## FINAL PLAT HENTZEN ADDITION TO SEDGWICK COUNTY, KANSAS

RE: SUB 2002-89 -- One-Step Final Plat of Hentzen Addition

**CASE NUMBER:** SUB 2002-89 – HENTZEN ADDITION

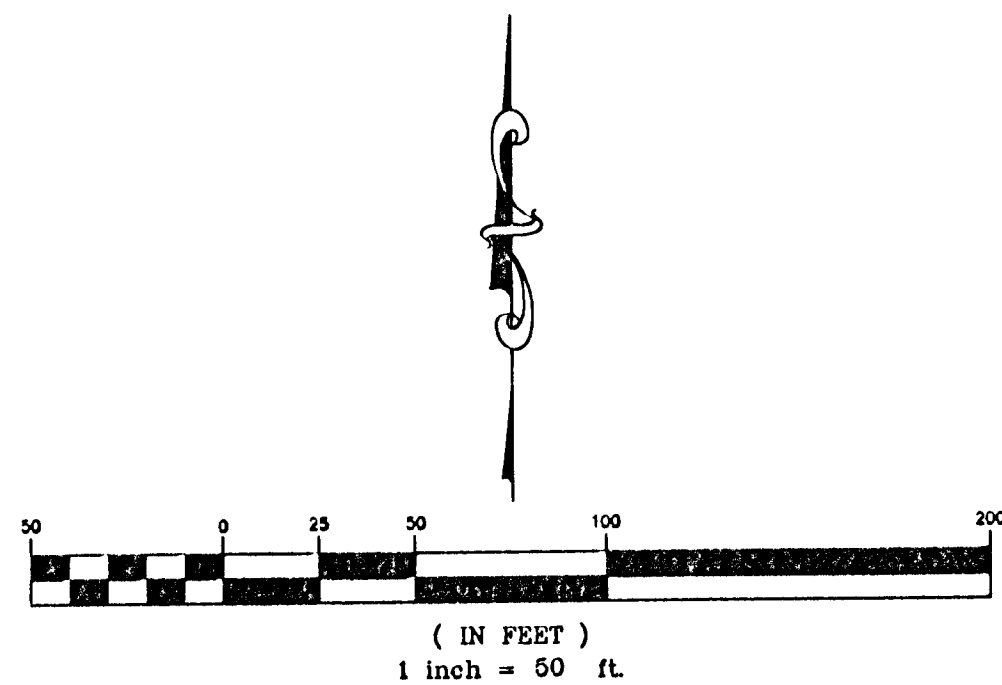
- C. **City Engineering** needs to comment on the status of the applicant's drainage plan. **The drainage plan is approved. A guarantee is required for drainage improvements.**

- D. The plat's text shall include the standard floodway language.
- E. The plat proposes two access openings along both arterials. The openings along 37<sup>th</sup> St. North are approved. In accordance with the Access Management Policy, the openings along 37<sup>th</sup> St. North and Hillside closest to the intersection need to be rights-in/out and denoted on the face of the plat. A guarantee is required for construction of a channelized rights-in/out opening. The opening along Hillside located along the south line of the plat is approved as a joint opening with the property to the south, contingent upon closure of the existing opening for the property to the south. In the event, the existing opening for the property to the south is not closed, then this opening should be relocated to be in alignment with the northernmost opening for the property across Hillside. Distances should be shown for all segments of access control. The final plat shall reference the dedication of access controls in the plat's text.

- F. The applicant shall guarantee the closure of the driveway opening located on the abutting property to the south.
- G. A petition is requested for accel and decel lanes, and modification of the traffic signal. A petition is requested for future left turn lanes along both arterials for the openings with full turning movements; which shall not be activated until determination of a need by the Traffic Engineer.

- H. The cross-lot access easement with the property to the south and internal access easements shall be established by separate instrument. Initial construction responsibilities and future maintenance of the driveway within the easement should also be addressed by the text of the instrument.

- I. Traffic Engineering has requested additional right-of-way along both arterials. The Access Management Policy requires a 60-ft half-street right-of-way width along urban arterials. The Policy also requires an additional 25-ft x 25-ft corner clip at the intersection. The Subdivision Committee approved a 50-ft half-street right-of-way.

- J. Provisions shall be made for ownership and maintenance of the proposed reserves. A covenant shall be submitted regarding ownership and maintenance responsibilities.

- K. For those reserves being platted for drainage purposes, the required covenant which provides for ownership and maintenance of the reserves shall grant, to the City, the authority to maintain the drainage reserves in the event the owner(s) fail to do so. The covenant shall provide for the cost of such maintenance to be charged back to the owner(s) by the governing body.

- M. On the final plat tracing, the MAPC signature block needs to reference "Michael E. Lindebak, Secretary".
- N. On the final plat, the MAPC signature block needs to reference "J.D. Michaelis, Chair".

- O. A signature line needs to be added for the owners.
- P. The Applicant is reminded that a platting binder is required with the final plat. Approval of this plat will be subject to submittal of this binder and any relevant conditions found by such a review.

- Q. The platlor's text shall include language that a drainage plan has been developed for the plat and that all drainage easements, rights-of-way, or reserves shall remain at established grades or as modified with the approval of the applicable City or County Engineer, and unobstructed to allow for the conveyance of stormwater.
